# SERVICE BULLETIN REVISION NOTICE

NACELLE - THRUST REVERSER RIGGING, PRESSURE RELIEF DOOR LATCHES –  
MODIFICATION OF

Turbojet Engine Service Bulletin No. V2500-NAC-78-0110 Revision No. 3 dated May 9, 2017

**NACELLE — THRUST REVERSER RIGGING, PRESSURE  
RELIEF DOOR LATCHES - MODIFICATION OF**

THRUST REVERSER SPLIT LINE GAP AND PRESSURE RELIEF DOOR MEASUREMENT  
FIGURE 1

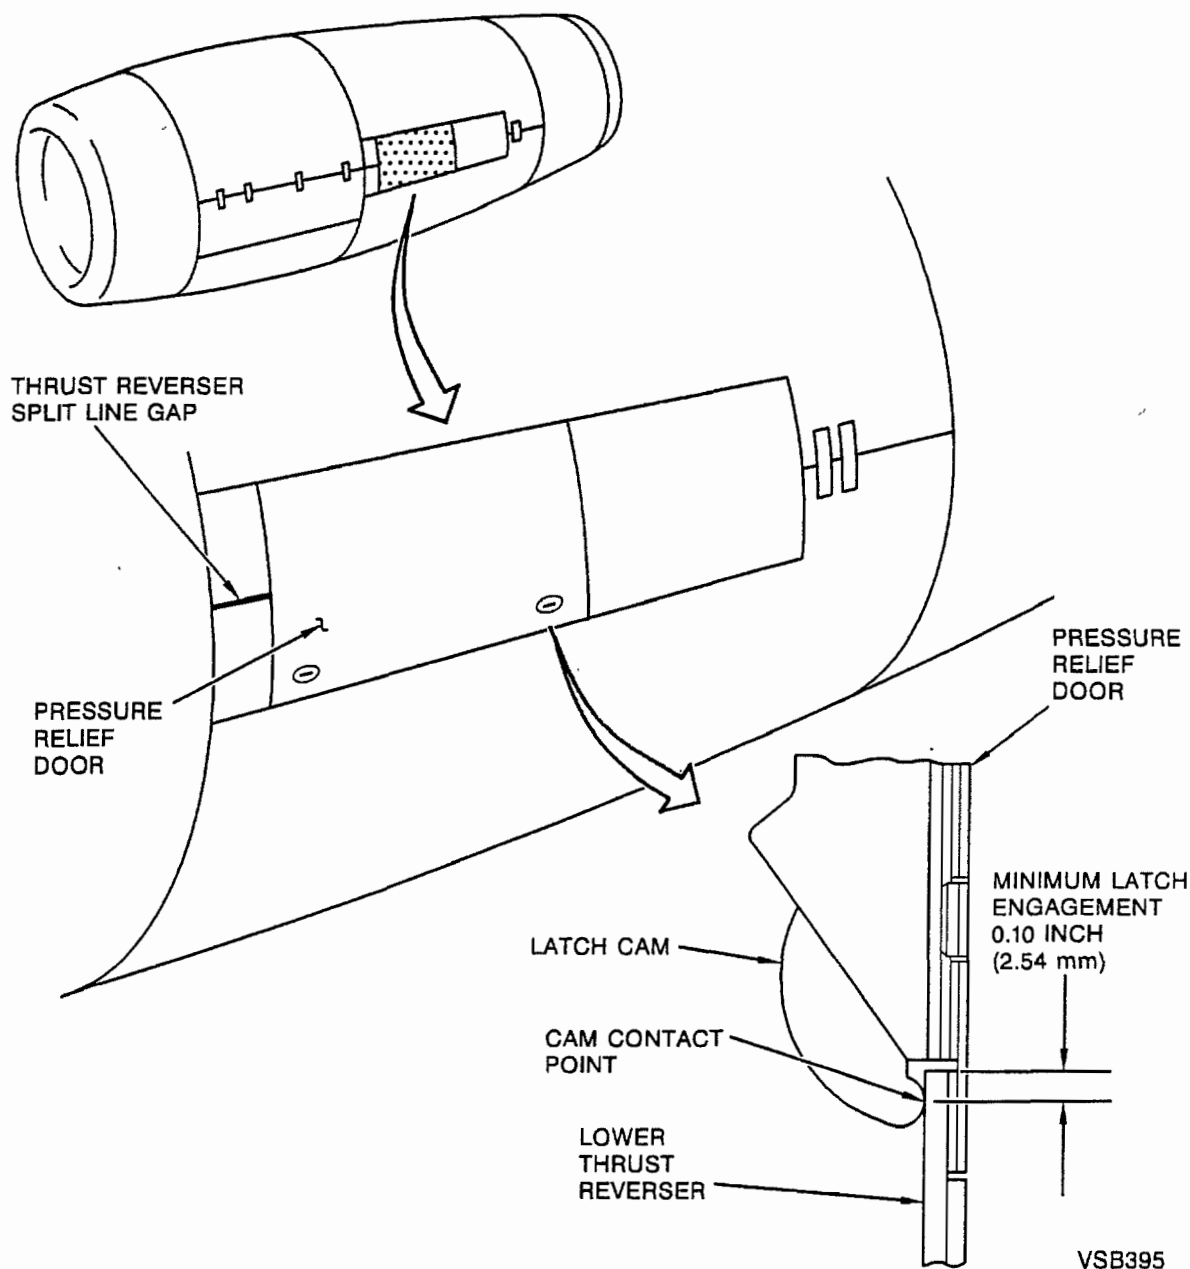
- (1) Measure the thrust reverser split line gap. The gap should be 0.010-0.160 inch (0.254-4.064 mm). Measure the pressure relief latch engagement. The engagement of both latches should be a minimum of 0.10 inch (2.54mm). Refer to Figure 1. If one or both measurements (thrust reverser split line gap or pressure relief door latch engagement) are not acceptable, perform the following thrust reverser rigging procedure.

- (m) Make sure that the engagement of the pressure relief door latches are a minimum of 0.10 inch (2.54 mm). Refer to Figure 1. If the minimum latch engagement is less than 0.10 inch (2.54 mm), contact your IAE customer support representative.

THRUST REVERSER RIGGING ADJUSTMENT  
FIGURE 2

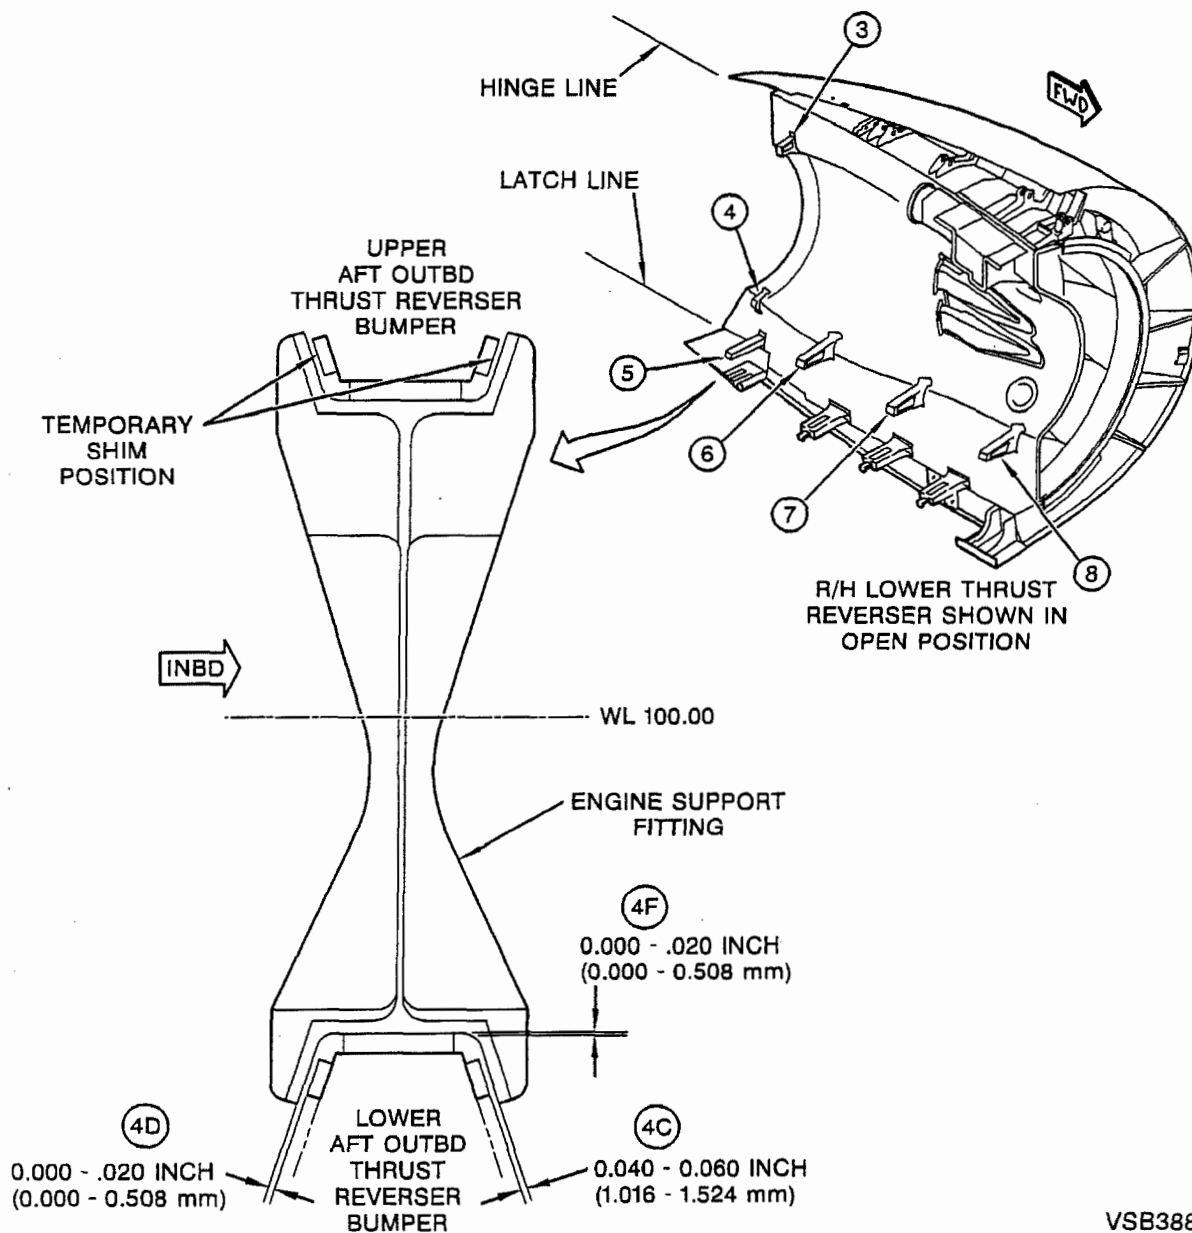
- (i) Open the lower C-duct. Refer to MD-90 Aircraft Maintenance Manual, Chapter 78-32-00, page block 201.
  - (j) Measure gaps between bumpers (thickness of clay) at positions 3, 4, 5, 6, 7, and 8. Refer to Figure 2.

- (k) Add shims to bumpers as required to attain gap of 0.000-0.020 in. (0.000-0.508 mm) at position 3, 0.010-0.050 in. (0.245-1.27 mm) at positions 5, 6, 7, and 8, and gap shown in Figure 2 at position 4.

PRESSURE RELIEF DOOR ADJUSTMENT  
FIGURE 3

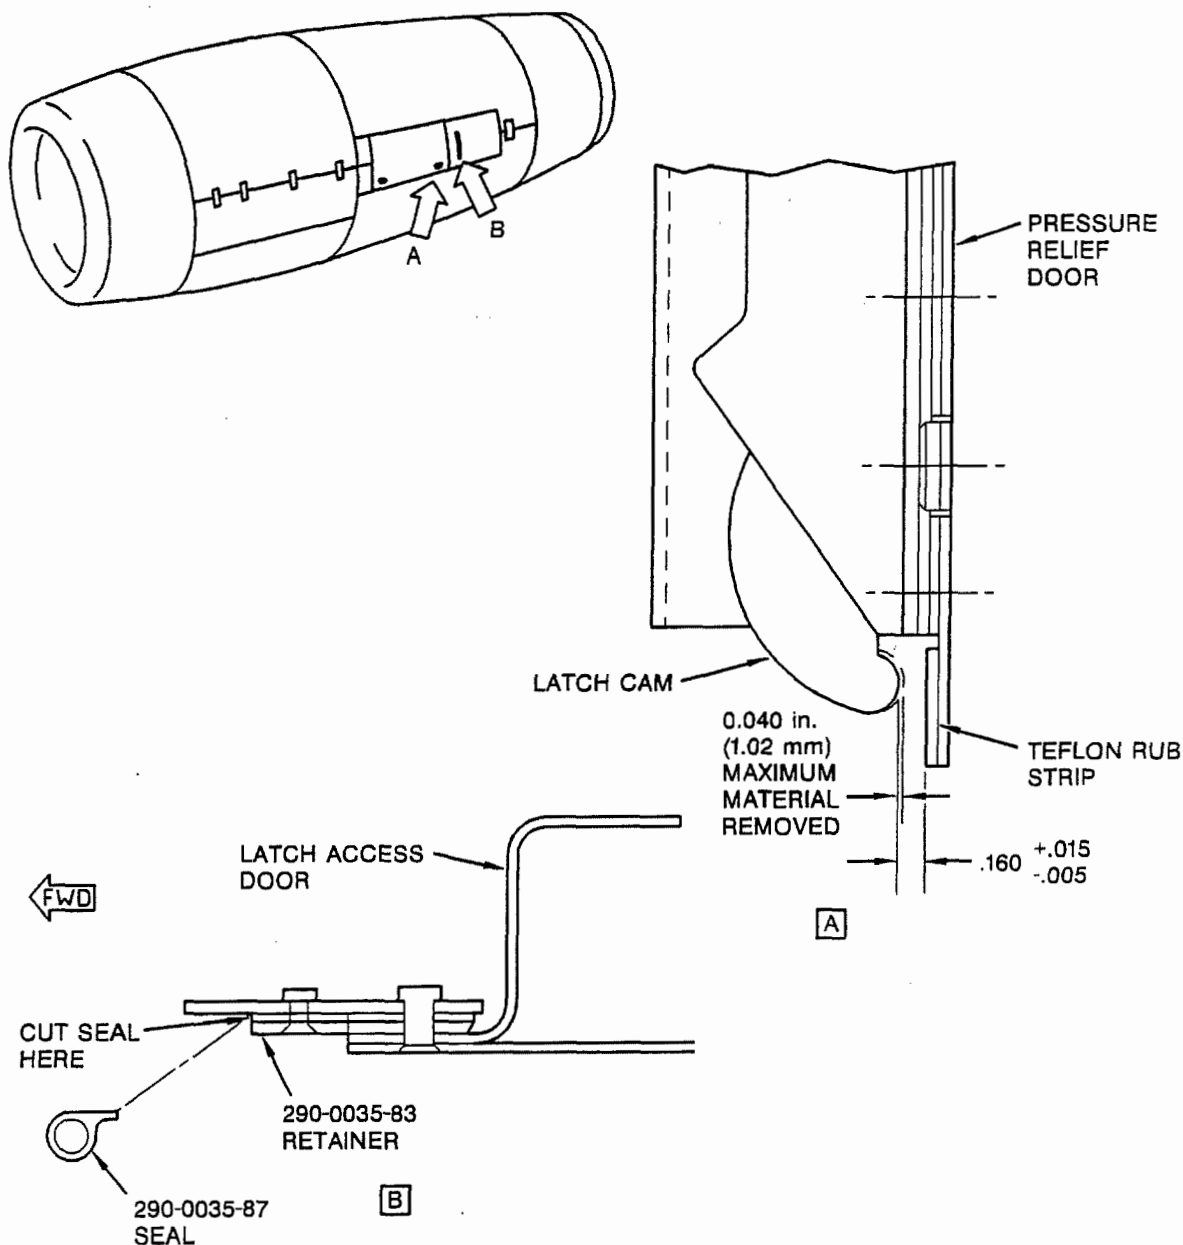
- (2) Open the thrust reverser pressure relief door.
  - (3) Modify the pressure relief door latches.
    - (a) Measure and record the distance between the latch cam and the teflon rub strip. Refer to Figure 3.

- (b) If the distance is less than the dimension shown, hand grind the latch cam with non-metallic abrasive to achieve the dimension shown in Figure 3. Keep the original radius.

LATCH RELEASE LOAD MEASUREMENT  
FIGURE 5

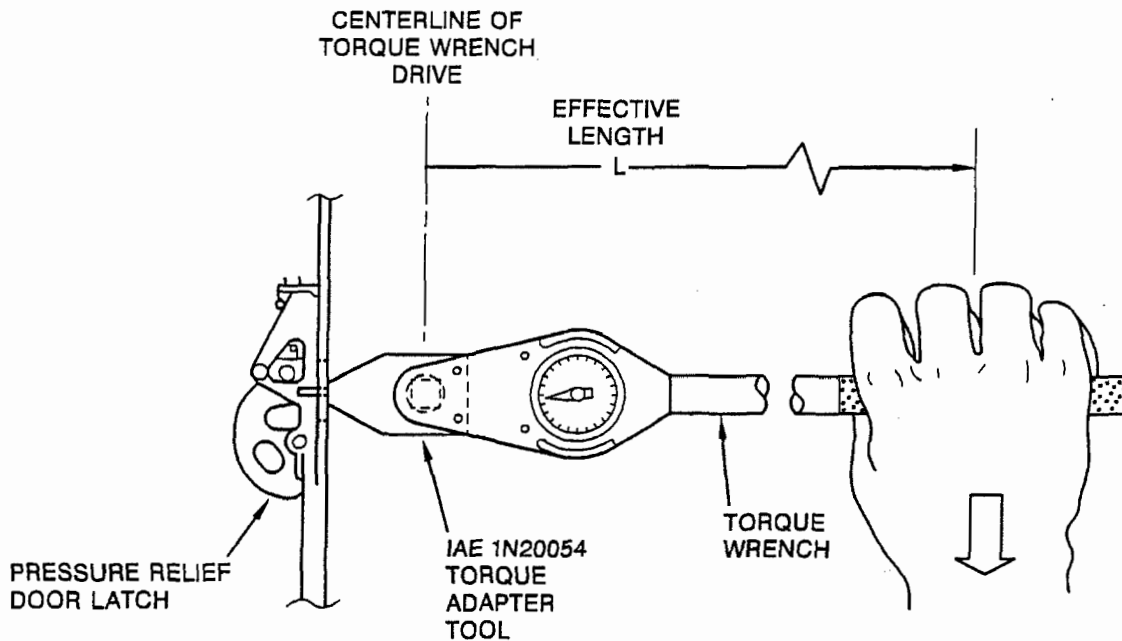
$$\text{LRL} = \frac{\text{Torque Reading} \times (L + 1.250)}{0.561 \times L} + 16.0$$

L = Distance from the centerline of the torque wrench drive to the center of the operators hand. Refer to Figure 5.

LATCH RELEASE MECHANISM ADJUSTMENT  
FIGURE 6

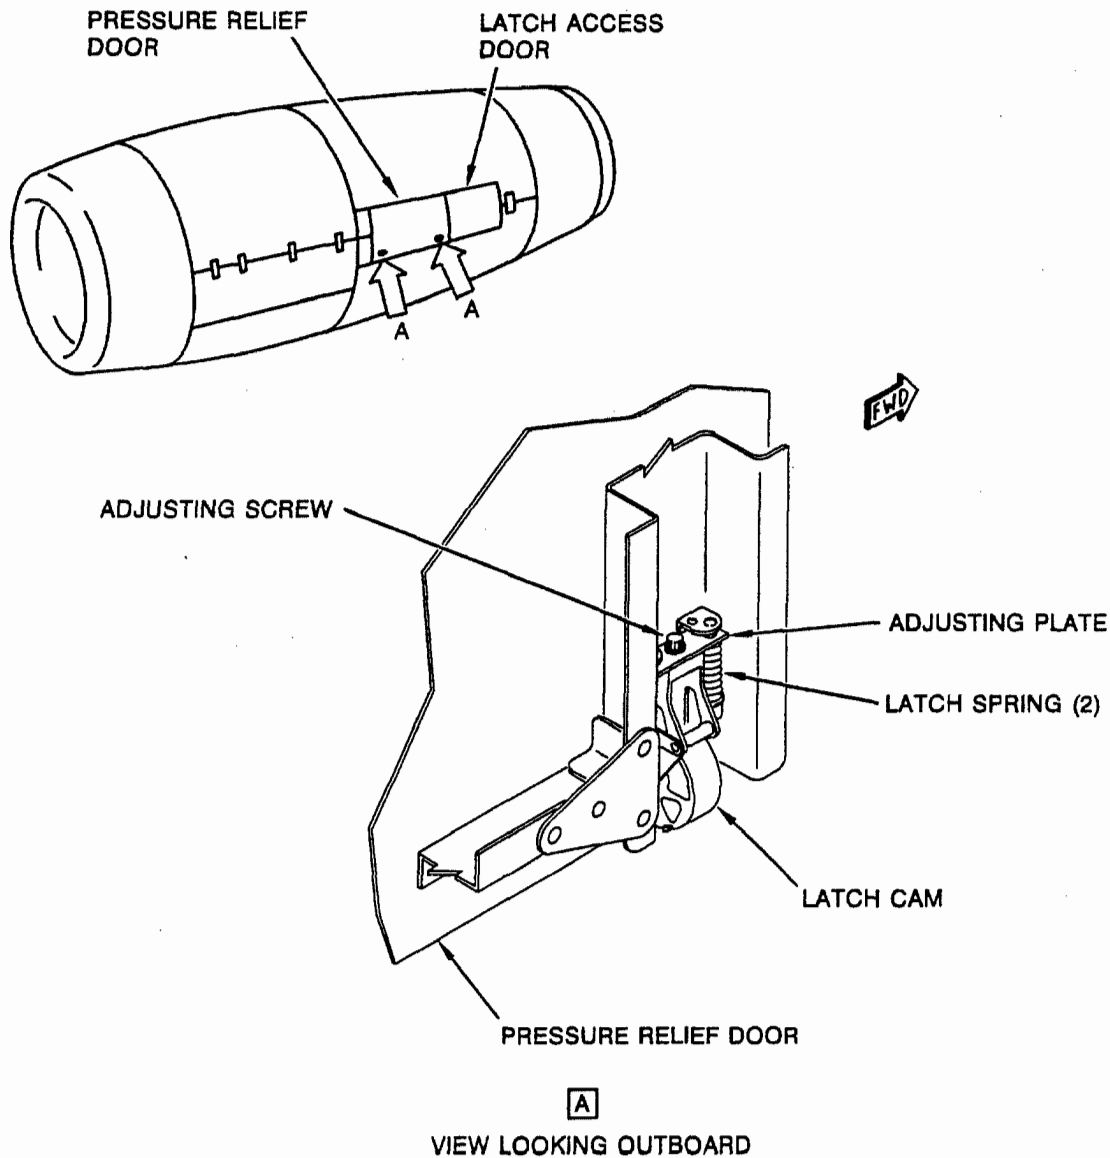
- (6) If the average closed door, latch release load is more than 329-369 pounds, no further action is required. If the average closed door, latch release load is less than 329 pounds, adjust the latch access door as follow:

- (a) Cut and remove the lockwire from the latch release mechanism adjusting screw. Refer to Figure 6.
  - (b) Tighten the adjusting screw as necessary.

- (e) Safetywire the adjusting screw to the latch release mechanism with 0.032 inch (0.813 mm) diameter lockwire (CoMat 02-147). Refer to IAE V2500 Standard Practices/Processes Manual, Chapter 70-42-05.
